Re: **Second Submission Review** – Porteos Infrastructure Site Plan (Preliminary Plat) Phase 8 – FDP Amendment and Preliminary Plat

**Application Number:** DA-1903-18  
**Case Numbers:** 2012-7001-07; 2020-6020-00

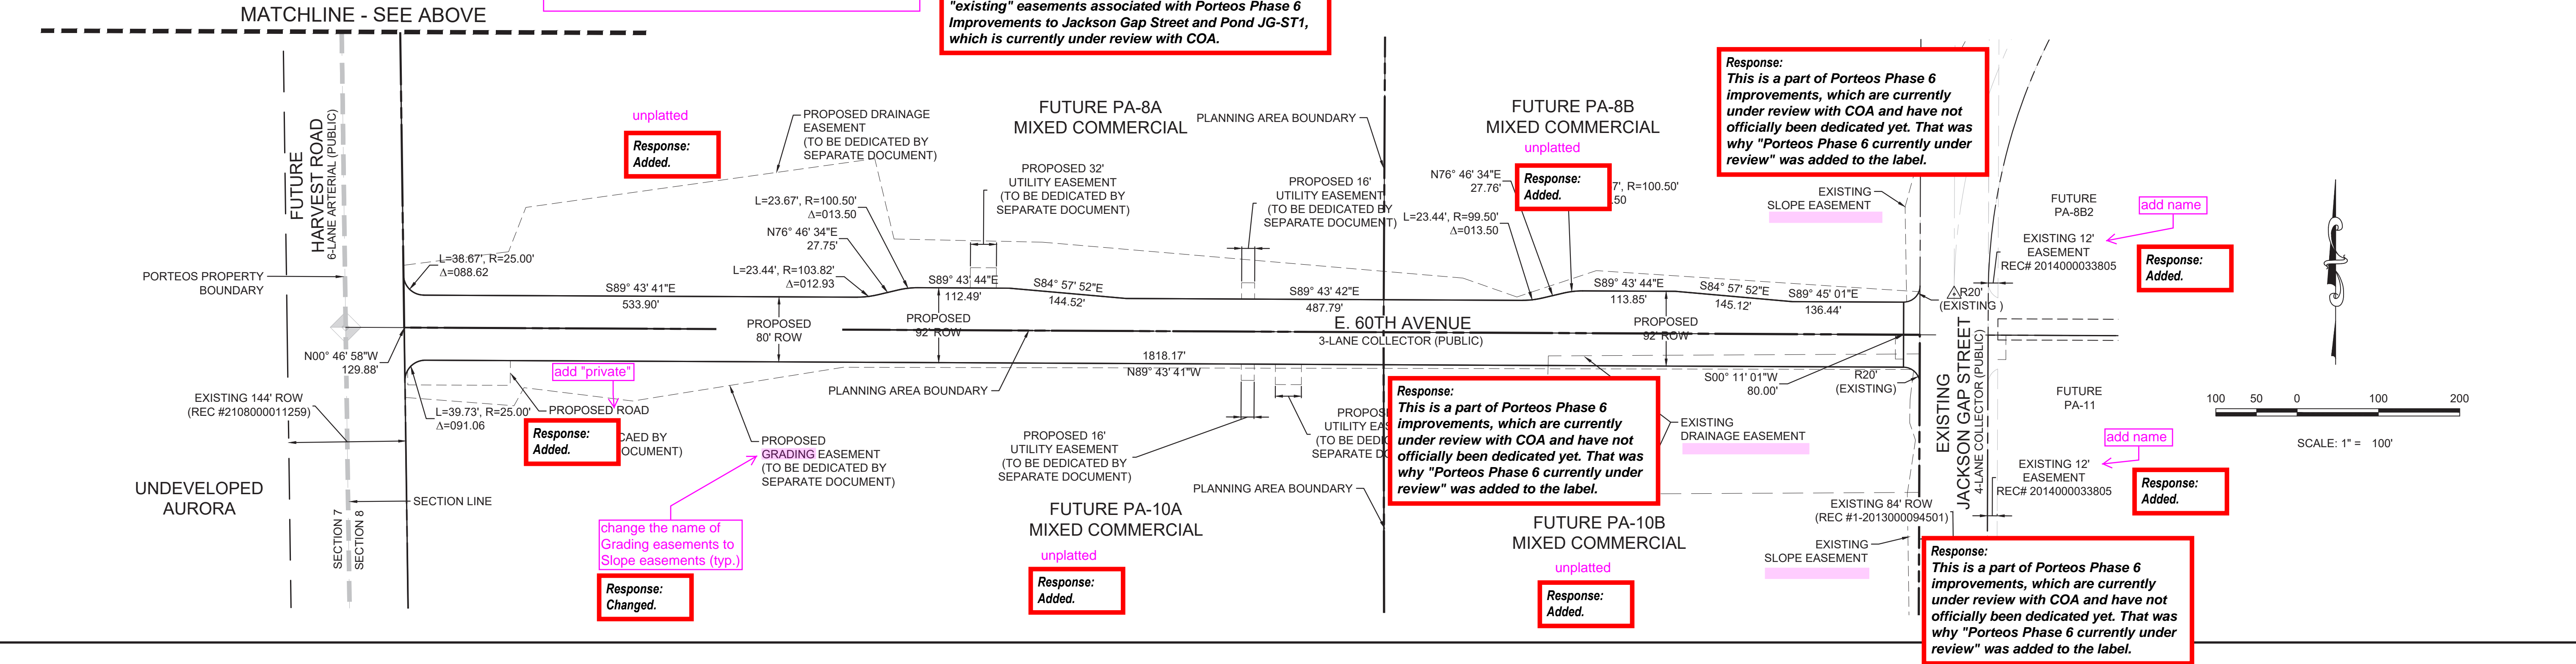
for all of these easements and R.O.W. Contact Andy Niquette by email at (aniquette@auroragov.org) to start the processes. Label the existing easements and R.O.W. with the specific reception no.

Response: CVL is coordinating with Andy Niquette regarding the proposed easement package. Existing ROW and easements have already been labeled, except for the "existing" easements associated with Porteos Phase 6 Improvements to Jackson Gap Street and Pond JG-ST1, which is currently under review with COA.

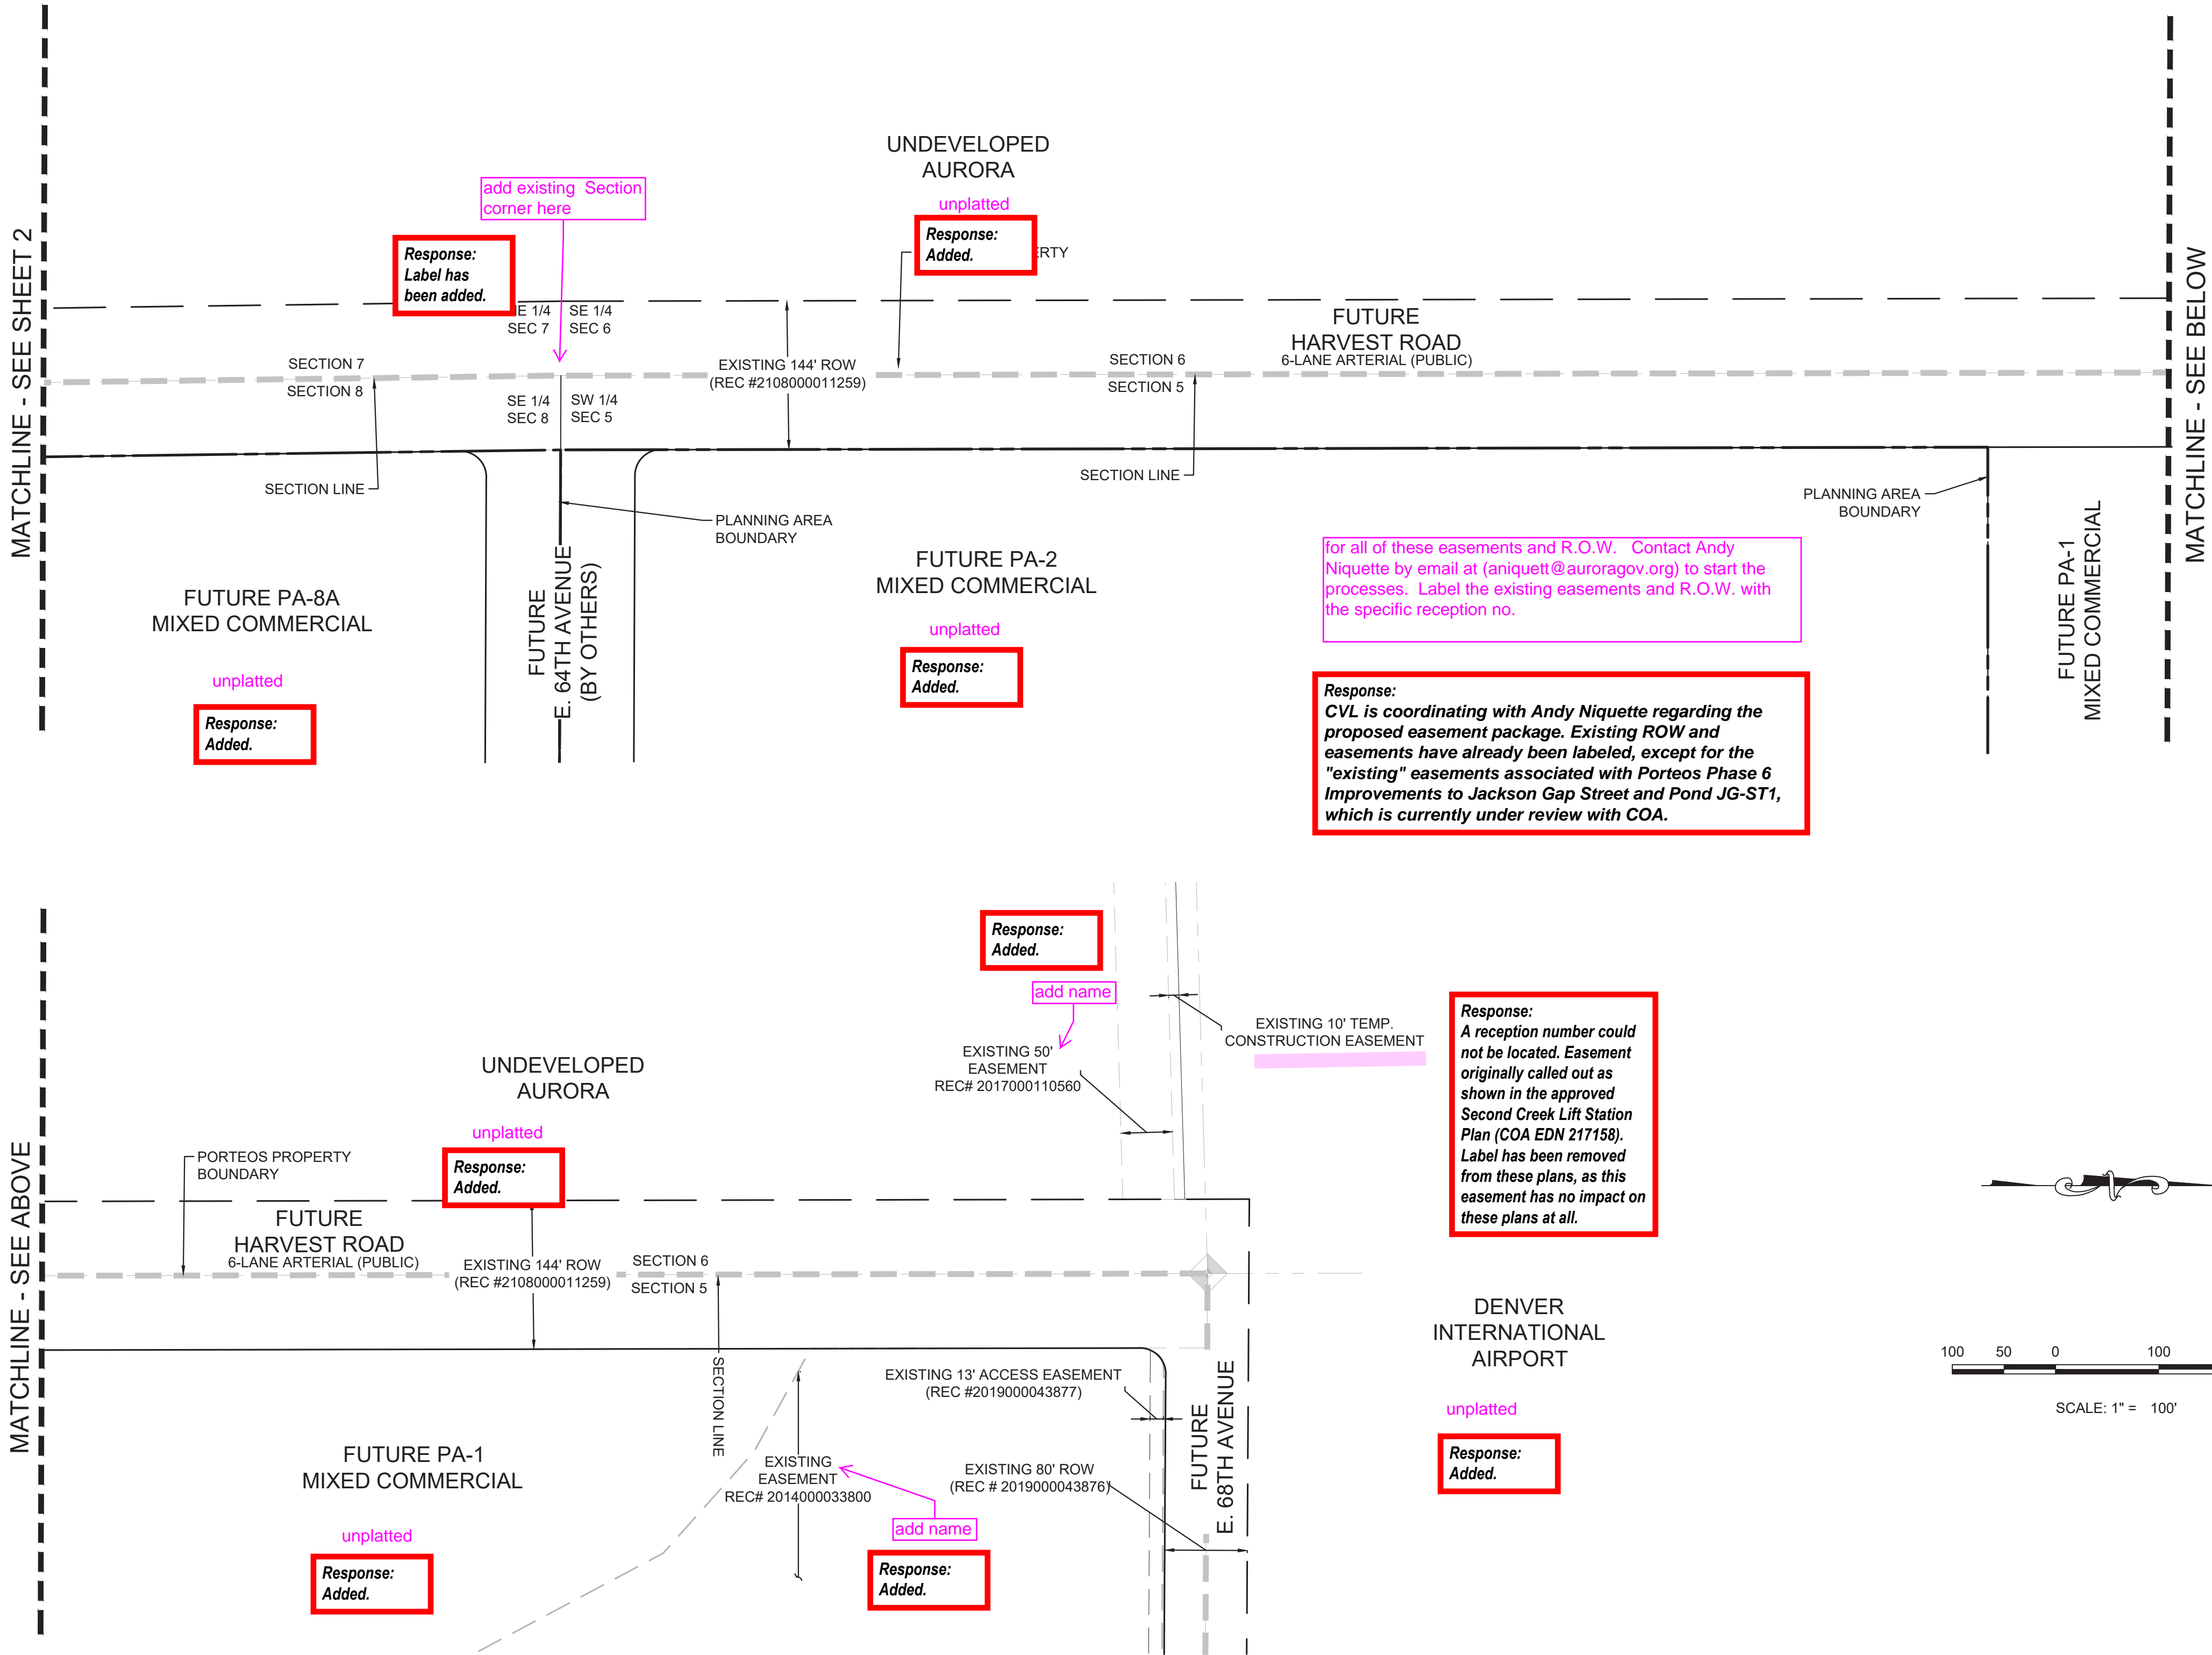
for all of these easements and R.O.W. Contact Andy Niquette by email at (aniquett@auroragov.org) to start the processes. Label the existing easements and R.O.W. with the specific reception no.

Show/label 100-year water surface elevation, emergency overflow direction

Less than 0.8% is not recommended for street design

for all of these easements and R.O.W. Contact Andy Niquette by email at (aniquett@auroragov.org) to start the processes. Label the existing easements and R.O.W. with the specific reception no.

label this Section Corner

Is the sidewalk going to be constructed in the turn around area? Please clarify. Also, the location of the street light is problematic in the interim. The intention is for a light to be on the west side of Harvest. This can be shown as a future light

ALL swales are required to be 2%, even those temporary in nature, typical

change the name of Grading easements to Slope easements (typ.)

Response: CVL is coordinating with Andy Niquette regarding the proposed easement package. Existing ROW and easements have already been labeled, except for the "existing" easements associated with Porteos Phase 6 Improvements to Jackson Gap Street and Pond JG-ST1, which is currently under review with COA.

Response: Pond is only providing for WQCV and EURV. Future detention will be accounted for with the development of adjacent parcels. EURV WSEL has been shown.

Response: Acknowledged. A grade of 0.5% is allowed per COA RRDCS 4.05.1, and it is only 0.5% for roughly 900'.

Response: CVL is coordinating with Andy Niquette regarding the proposed easement package. Existing ROW and easements have already been labeled, except for the "existing" easements associated with Porteos Phase 6 Improvements to Jackson Gap Street and Pond JG-ST1, which is currently under review with COA.

Response: This is a half section corner for section 8. Section corners are located at E 56th Ave and future Harvest Road and at future E 64th Ave and future Harvest Road.

Response: No, the sidewalk and curb and gutter on the south side for this stretch will be installed when Harvest Road is constructed. The linework has been shaded back and labels have been added. Light has been shaded to future layer.

Response: Changed.

Revisions		No.	Date	Appr.	Date
RESUBMITTAL		NO.1	7/10/20	JF	
PROJECT INFORMATION		PORTEOS - PHASE 8 INFRASTRUCTURE SITE PLAN EAST 60TH AVENUE ROAD PLAN VIEW			
DRAWN BY:		AS SHOWN	FILE NO:	8130249709	
CHECKED BY:		JFF	DATE:	FEBRUARY 2020	
SHEET NUMBER		4	OF 10

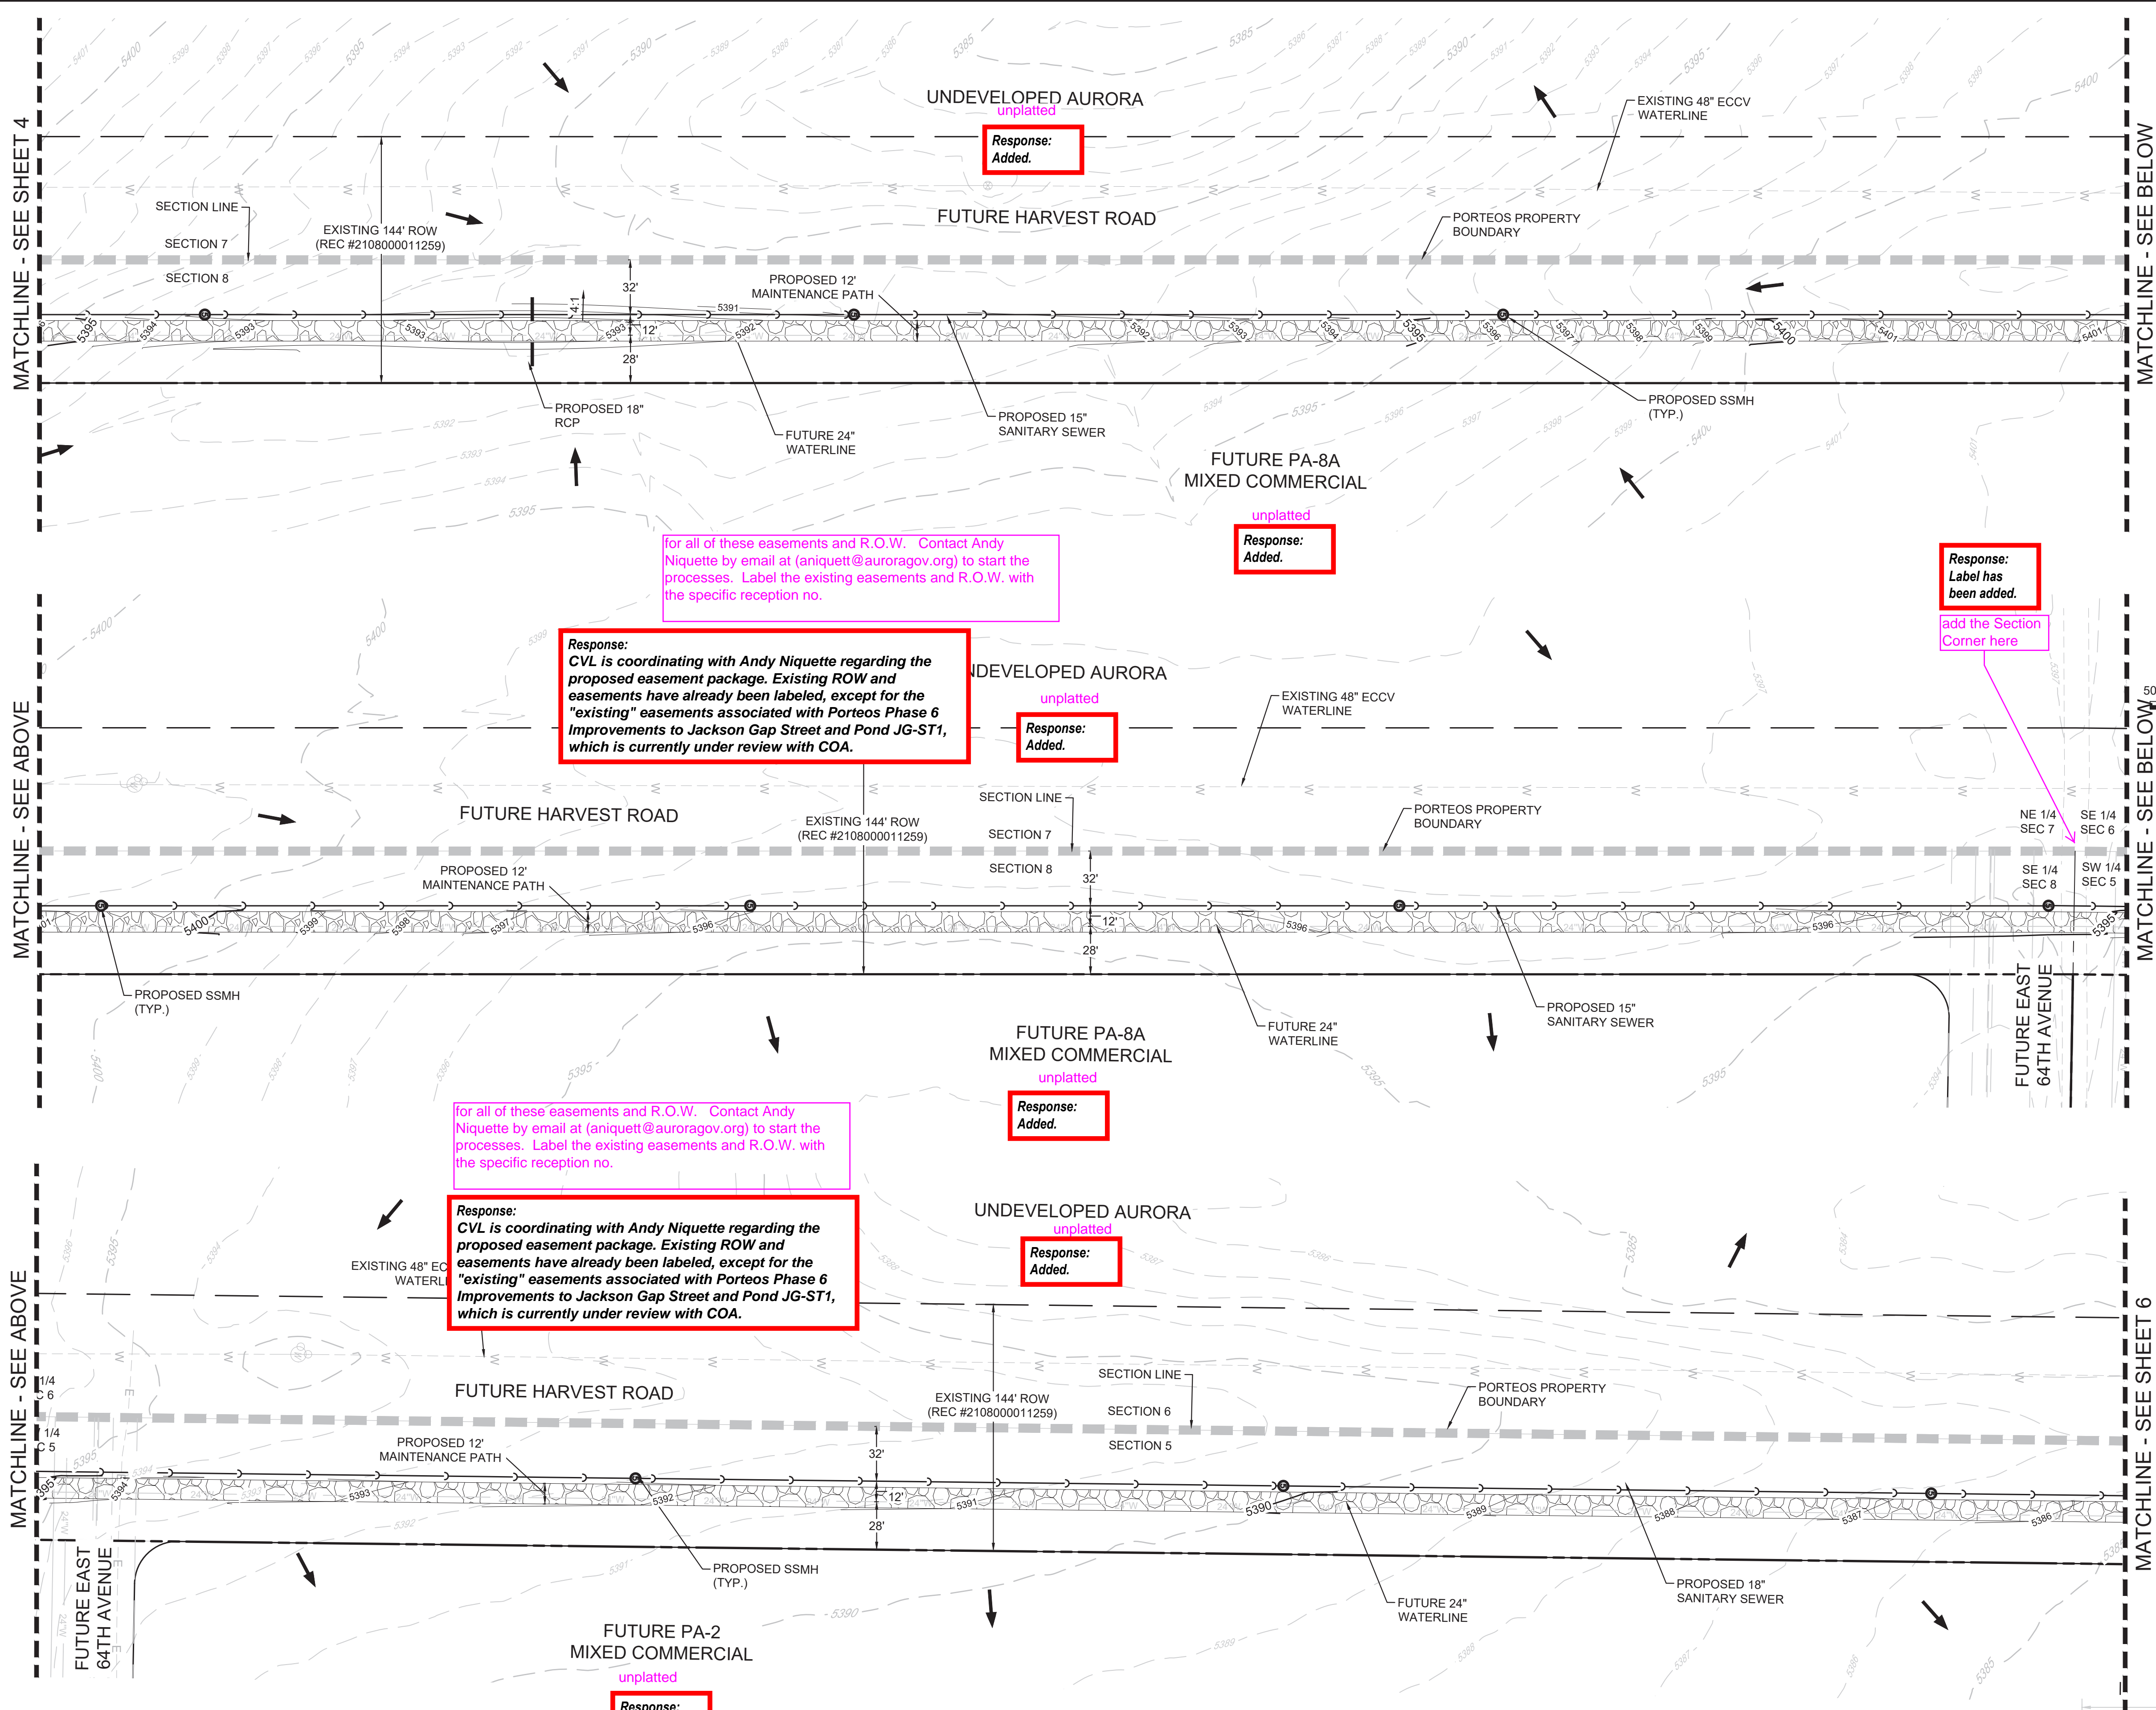
4B. Sheet 4- Less than 0.8% is not recommended for street design. Show/label 100-year water surface elevation, emergency overflow direction.

- Is there any need to be rock? (typ.)

- What sort of bank stabilization is proposed here?

- The way this outfall is set up will cause the water to expand at the wing walls, then contract again as it flows around the bend.  
***Response: Culvert has been realigned and the grading/outfalls have been revised accordingly.***
- Formalize this outfall, either outfall to the channel with appropriate outfall protection, or to a level spreader. As currently configured this would erode the banks of the proposed channel.  
***Response: Culvert has been realigned and the grading/outfalls have been revised accordingly.***
- Should the alignment of this culvert be changed to better match existing flow patterns?  
***Response: Culvert has been realigned to match the existing natural tributary more closely.***

**Response: Acknowledged. A grade of 0.5% is allowed per COA RRDCS 4.05.1, and it is only 0.5% for roughly 900'. Pond is only providing for WQCV and EURV. Future detention will be accounted for with the development of adjacent parcels. EURV WSEL has been shown.**

**Response: No rock shall be needed.**

**Response: Type M rip/rap will be used.**
